Access Compliance Report

Public Rights-of-Way

(Curb Ramps)

Intersection ID: 44158	Main Street: MEADOW_KNOLL_DR	Cross Street: FEATHER_BEND_CT	Location: NW
ADA ID: 8776E833950C	Ramp Type: BlendTrans1	Initial Pass/Fail: Fail	Overall Compliance: No
			Severity Score: 33.75

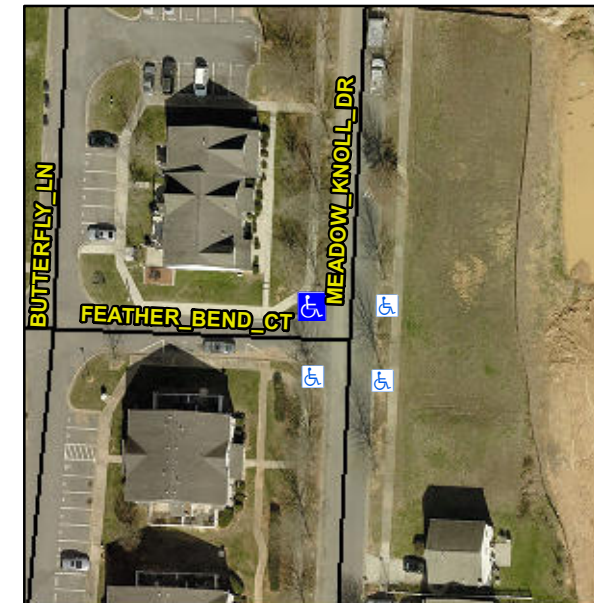
LNDG LIP 0.5

R304.5.1, R304.5.3

Compliance	Description	Data	Compliance	Description	Data
N/A	Ramp Length (in)	85.0	Yes	BlendTrans Slope (%)	2.2
No	Ramp Width (in)	46.5	No	BlendTrans XSlope (%)	9.9
N/A	Flare Type LT	N/A	N/A	Flare Type RT	N/A
N/A	Flare Slope LT (%)	N/A	N/A	Flare Slope RT (%)	N/A
N/A	Flare Traversable LT?	N/A	N/A	Flare Traversable RT?	N/A
N/A	Landing Length (in)	N/A	N/A	DWS Provided?	N/A
N/A	Landing Width (in)	N/A	N/A	DWS Contrast?	N/A
N/A	Landing Slope (%)	N/A	N/A	DWS Length (in)	N/A
N/A	Landing X Slope (%)	N/A	N/A	DWS Full Width?	N/A
N/A	Landing Curb? (Y/N)	N/A	N/A	DWS Offset (in)	N/A
N/A	Shared Landing?	N/A			
N/A	Gutter Ponding?	N/A	N/A	Gutter Slope (%)	N/A
N/A	Gutter Lip Ht (in)	N/A	N/A	Gutter X Slope (%)	N/A
N/A	Painted X Walk1?	No	N/A	Painted X Walk2?	No
	X Walk 1 Direction	To S		X Walk 2 Direction	To E
	X Walk 1 Width (in)	N/A		X Walk 2 Width (in)	N/A
	X Walk 1 Slope (%)	4.3		X Walk 2 Slope (%)	4.3
	X Walk 1 X Slope (%)	5.5		X Walk 2 X Slope (%)	7.2

Remove & Replace Curb Ramp With Two New Directional Ramps or Equivalent.
